# **Appendix O. Comments Received on Upper Columbia Alternative Flood Control and Fish Operations Draft EIS, & Responses**

## ALPHABETICAL LIST OF COMMENTERS

Section 1.4.5 Interim Implementation of VARQ FC

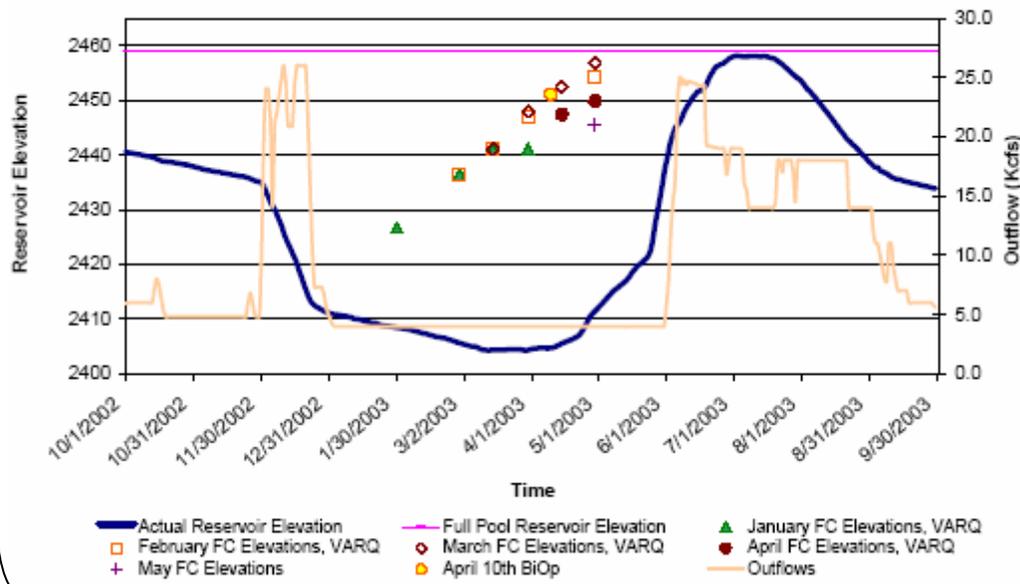
The DEIS states that the Corps implemented VARQ operations at Libby in 2003, however, that is not the case. Based upon the flow and elevation data for Libby in 2003 (FPC 2003), the Corps was not able to implement VARQ operations that year. As depicted by the following data, Libby was drafted well below flood control rule curves throughout the winter. Despite low runoff forecasts in December, the Corps prematurely drafted Libby to msl 2411 which set the stage for the inability to implement VARQ operations to refill Libby. The final environmental impact statement should correct this inaccuracy.
